## CITY OF TONTITOWN PLANNING OFFICE

Meeting: **September 28, 2021**  
Project: **WM Container Shop**  
Planner: Courtney McNair,  
Garver

### PRELIMINARY LARGE SCALE DEVELOPMENT REQUEST

**SUMMARY:** Request to construct a 1,904 SF shop building in order to repair trash containers at the existing WM Hauling Company site.

3 EXTERIOR ELEVATION - EAST  
SCALE: 1/4" = 1'-0"

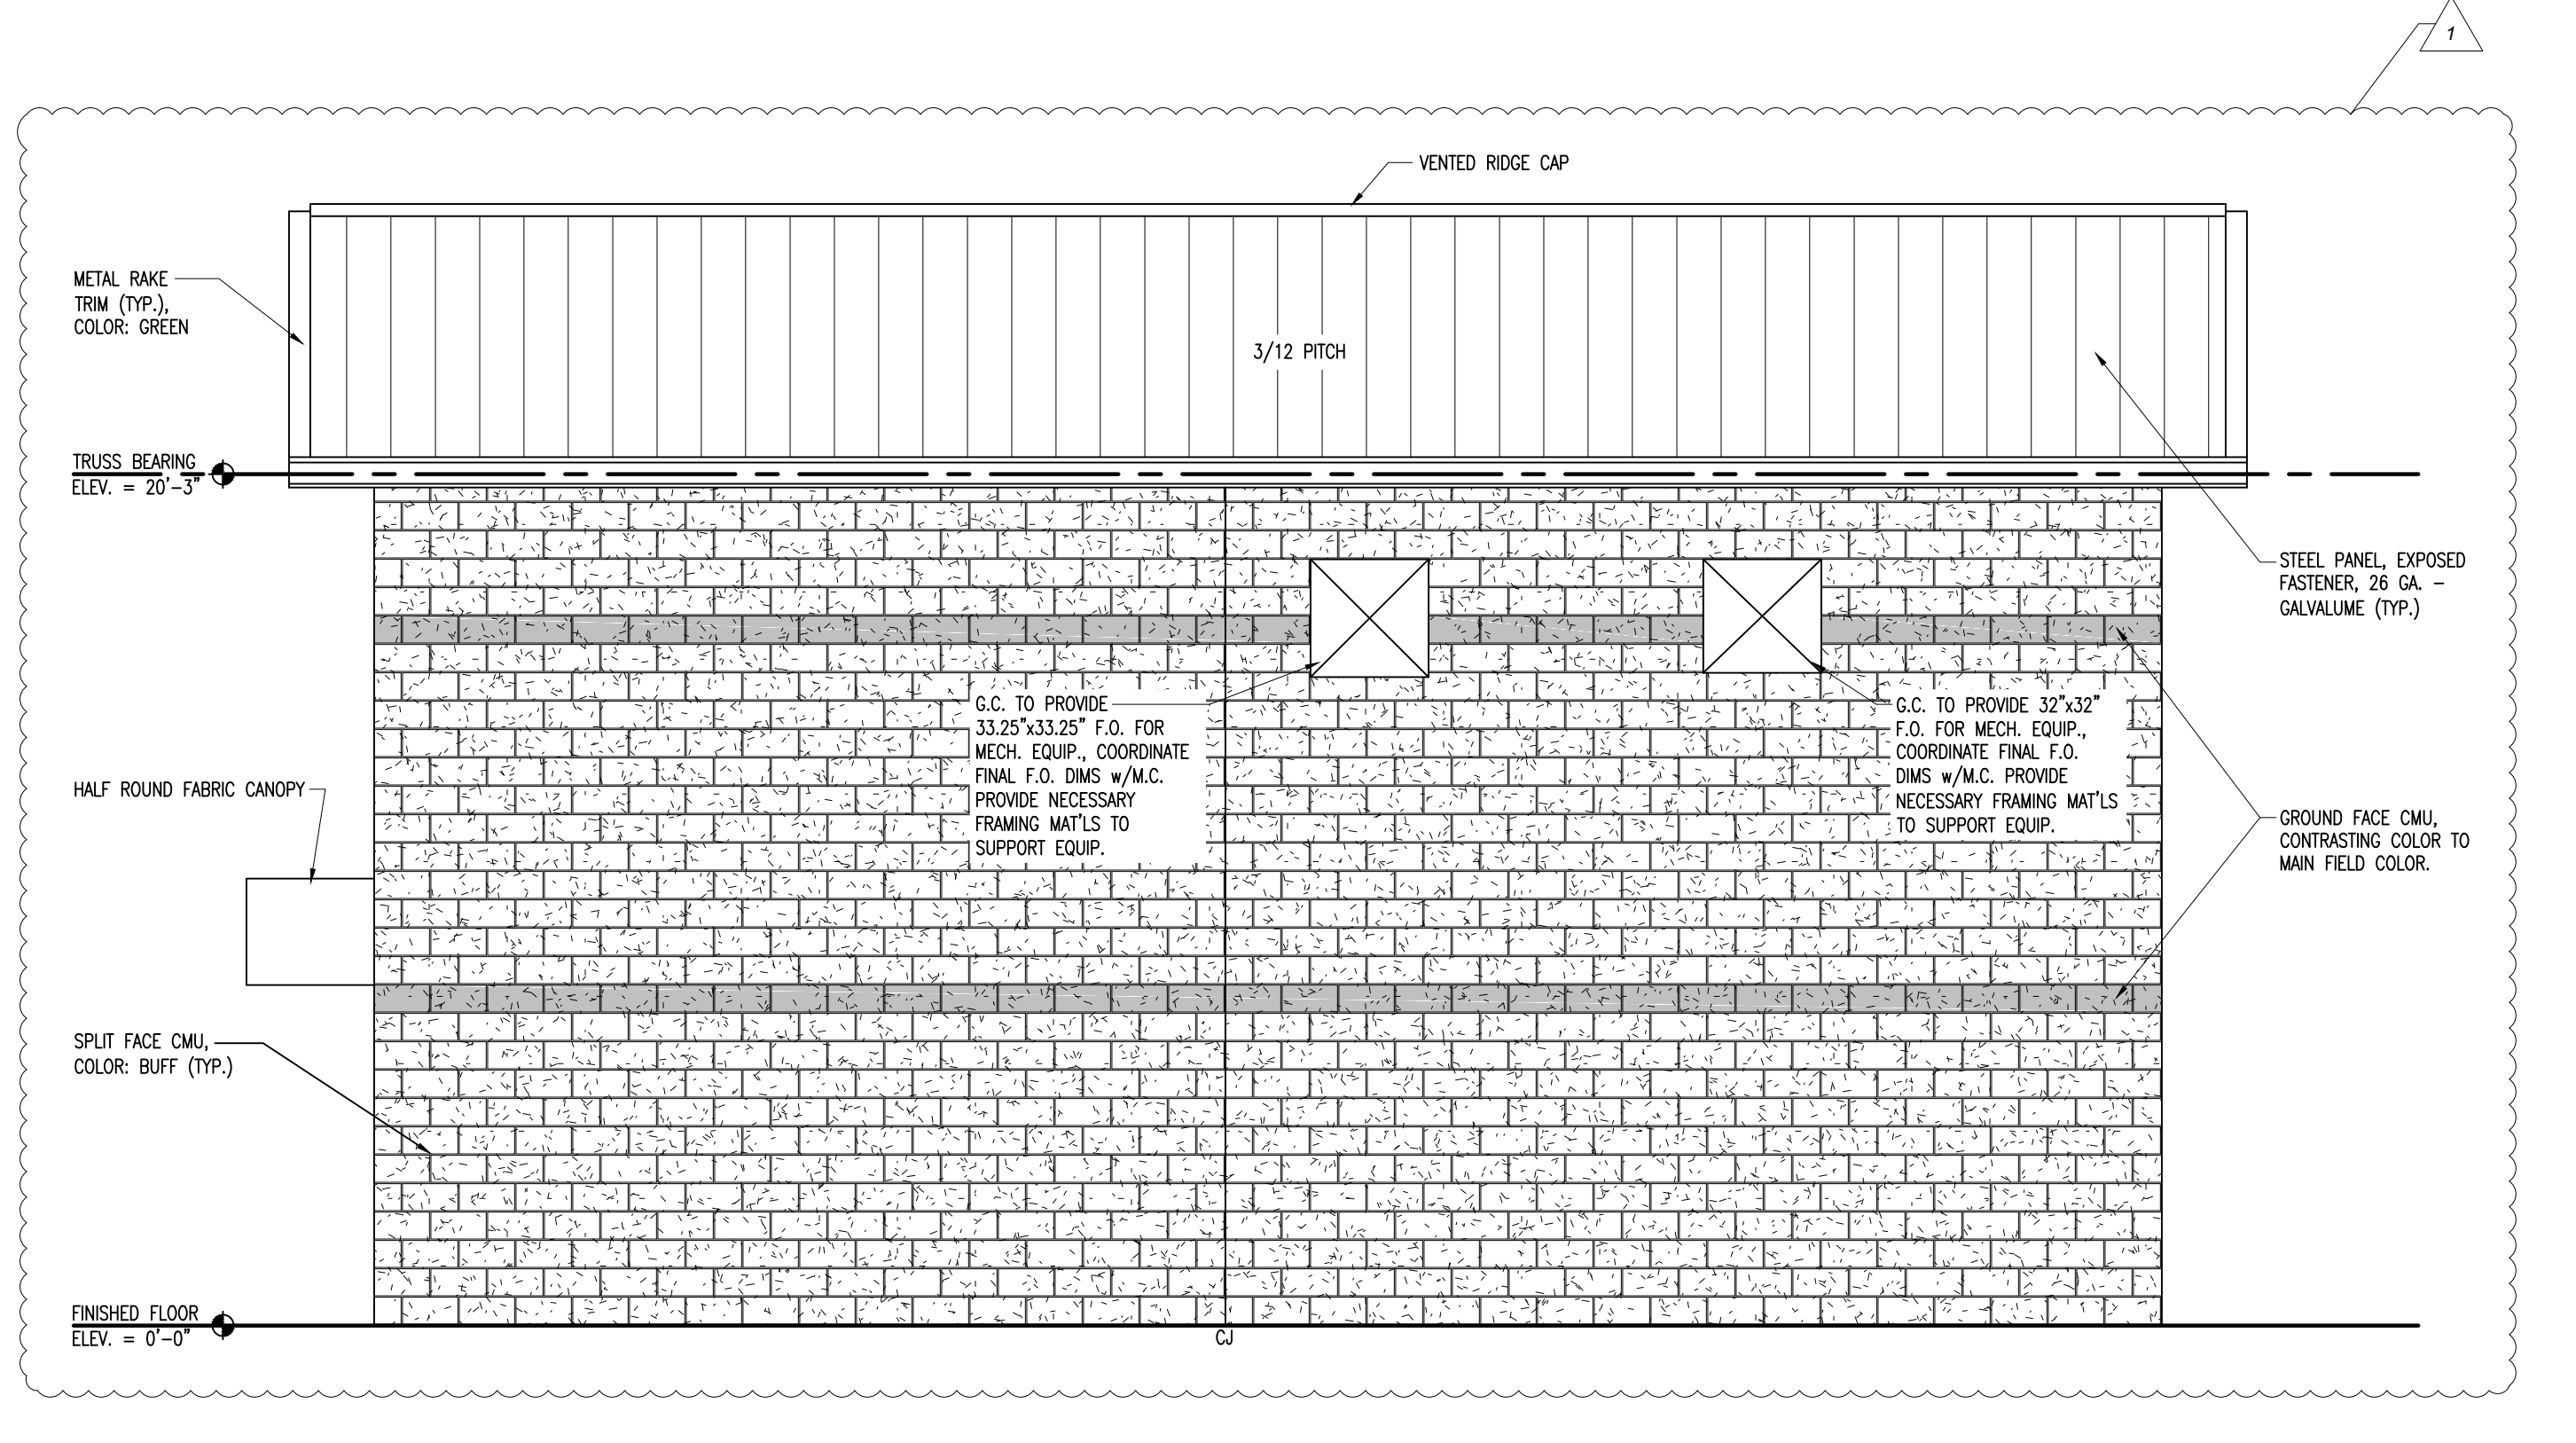
The applicant has submitted architectural elevations, and the building is in compliance with the requirements for the façade. The lighting cut sheet and photometric plan have been submitted and are adequate.
